TECHNICAL NOTE

DATE:	01 November 2022	CONFIDENTIALITY:	Public
SUBJECT:	Site A – Response to Drainage Officer Comments		
PROJECT:	Bognor Golf Course	AUTHOR:	Andy Smith

This Technical Note has been produced to provide a detailed response to the Drainage Officers comments on the surface water drainage strategy for Site A which was developed to support the Hallam Land Management Ltd's planning application for the redevelopment and relocation of the existing Golf Course (planning app ref: M/16/22/PL and FP/274/21/OUT).

drawn by LJM	checked by NJE	date 05 Oct 22
scale 1:2000		paper size A1
job/dwg no. 171-UW-P-A-016		rev B

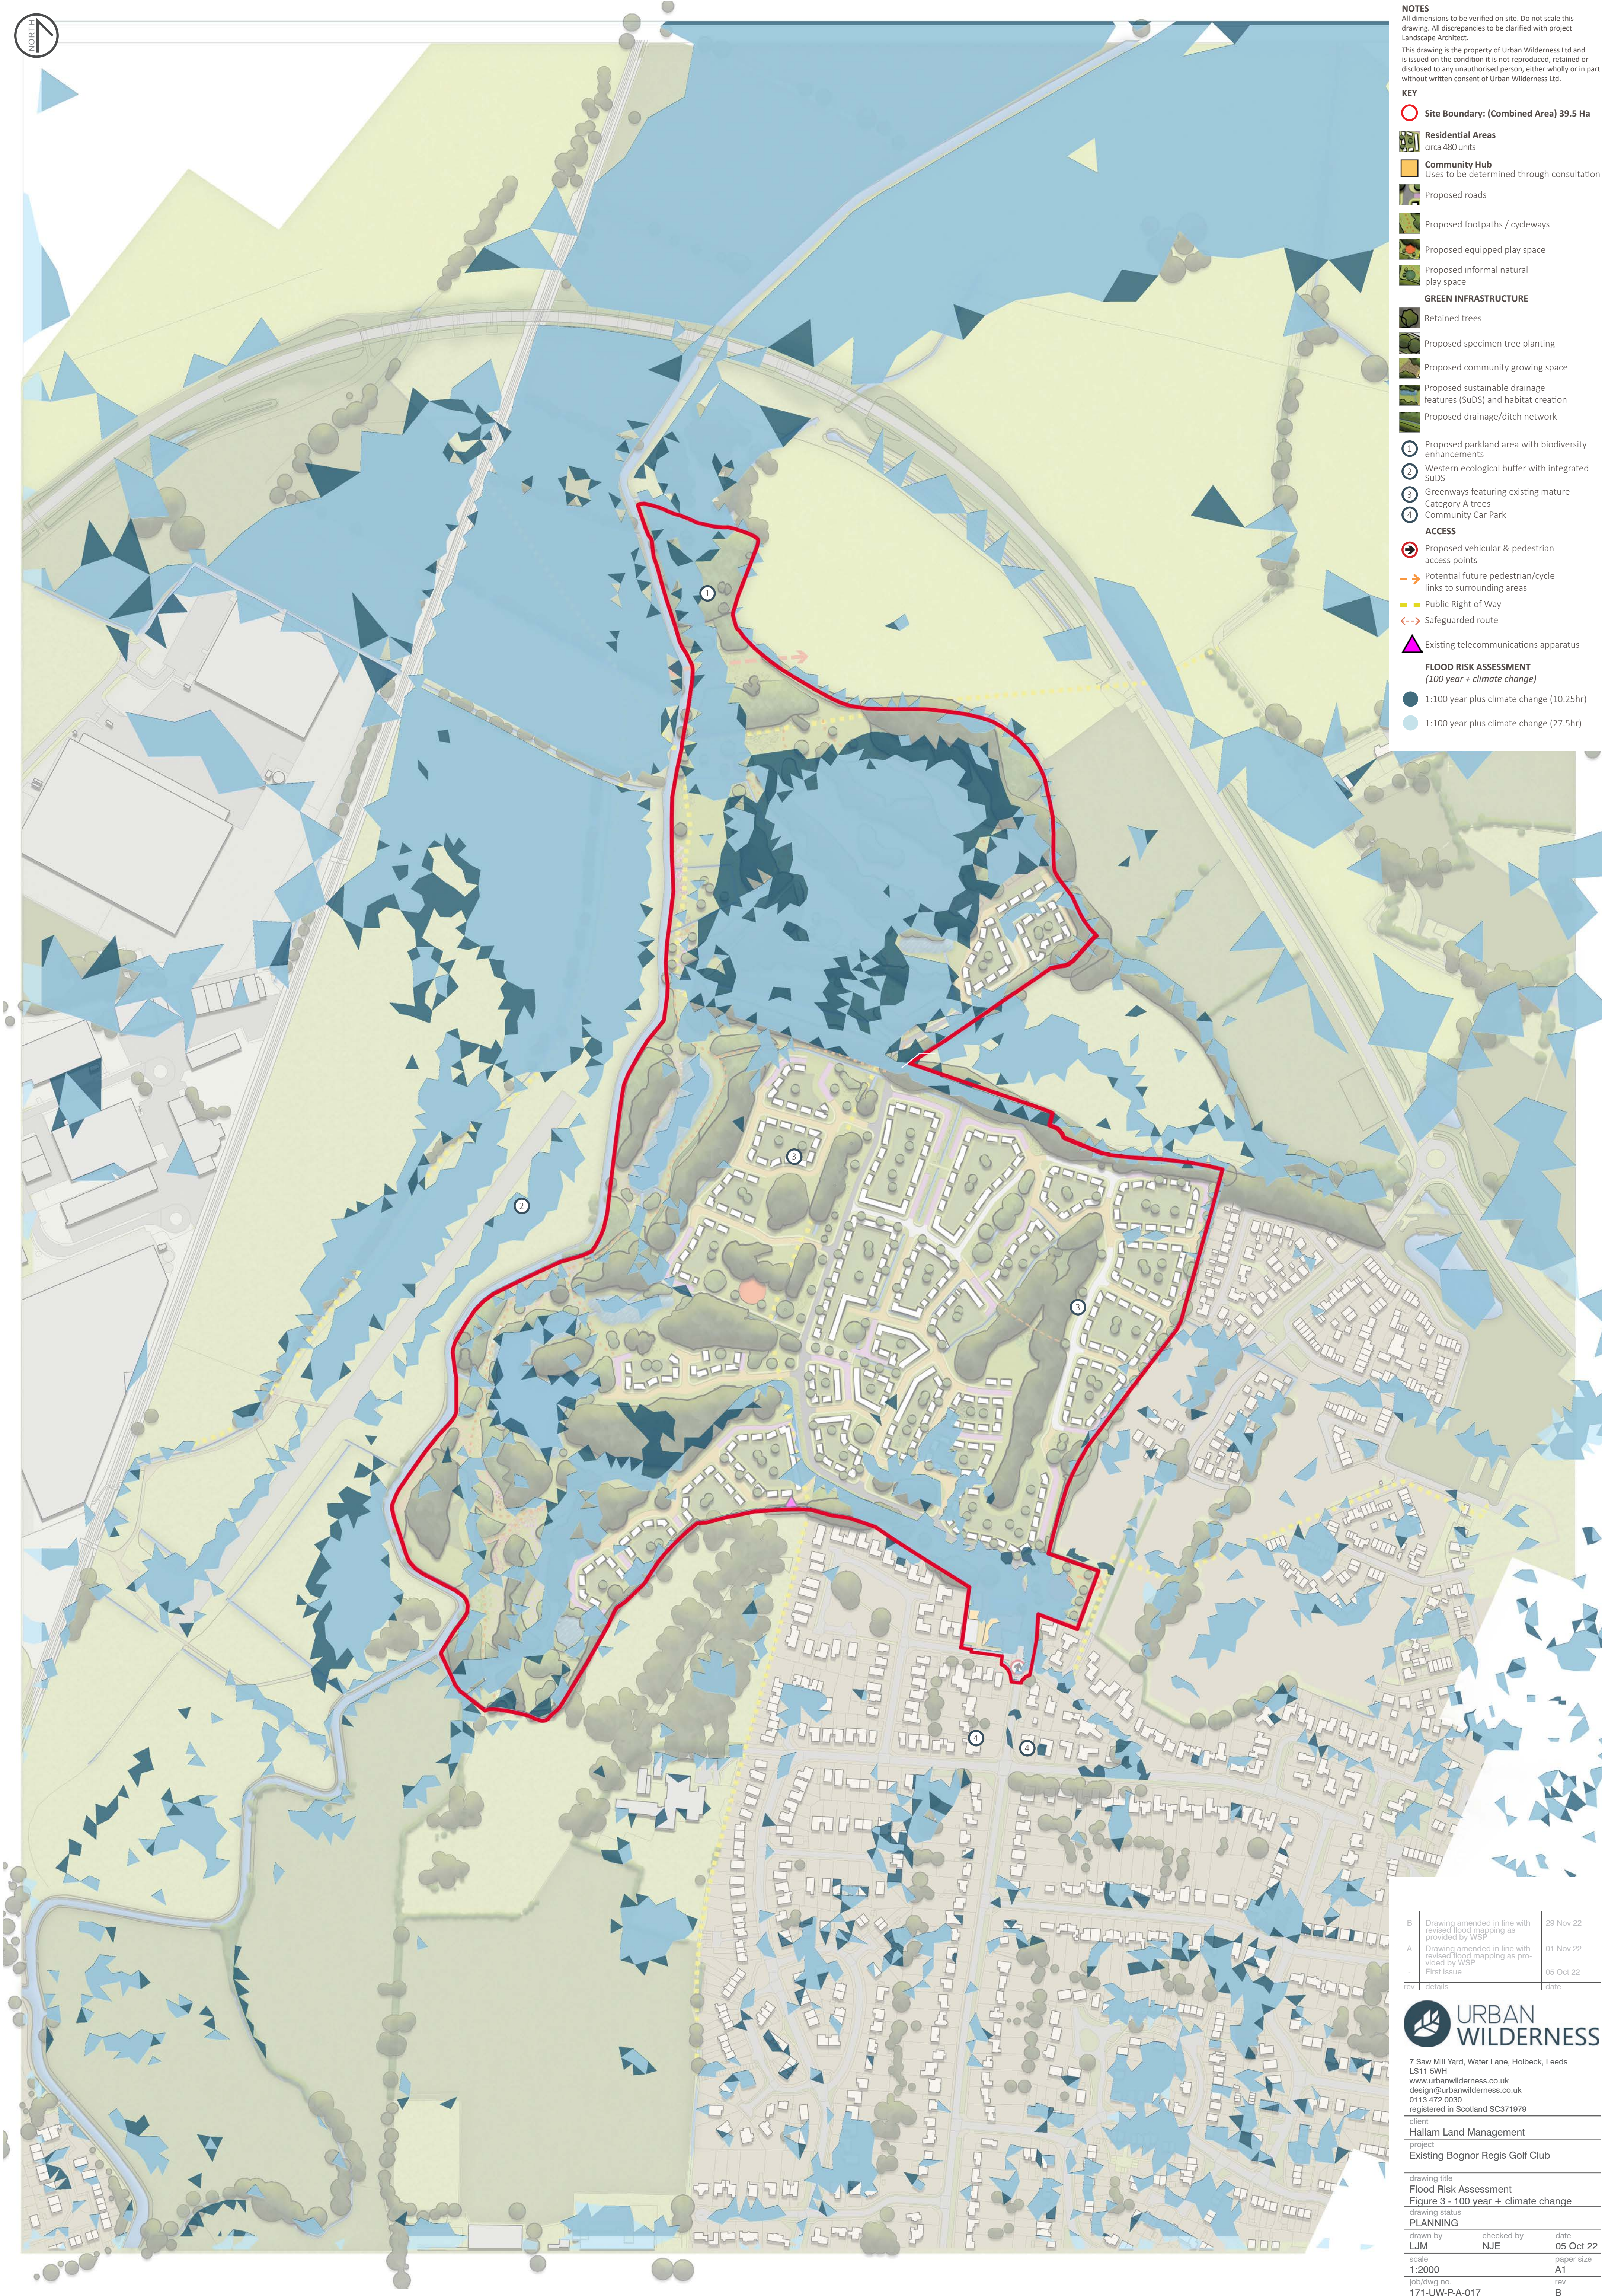
3 - No clear surface water drainage proposals are provided for either site. We appreciate that proposed 3D ground modelling is provided but more information needs to be provided on where the proposed development impermeable areas are draining to, attenuation provisions and where the surface water is ultimately being discharge to. The surface water calculations need to be provided to demonstrate that the run-off from these areas can be accommodated within the proposed attenuation features. In addition, clear information on the modelled fluvial flood level in relation to the attenuation features needs to be provided and surface water calculations need to demonstrate the impact of joint probability events. This is to ensure that the quantum of development proposed at outline stage is achievable and that the surface water drainage proposals comply in not increasing the risk of flooding elsewhere or onsite. In addition to this the locations of the proposed SuDS must clearly be outside of the impacts of the modelled fluvial flood extents.

The flood modelling, which is currently being approved by the Environment Agency (point 1) demonstrates that all the ponds (A, B, C and D) are not at risk of fluvial / pluvial flooding for the design event including the latest climate change allowances. The flood maps are appended, whilst ponds C and D are shown to be dry, water is shown to be within ponds A and B due to their size and the direct rainfall nature of the flood model which applies rainfall to the whole catchment (including the site), the result is that some water directly falls onto the ponds whereas other flows in through the ditch network.
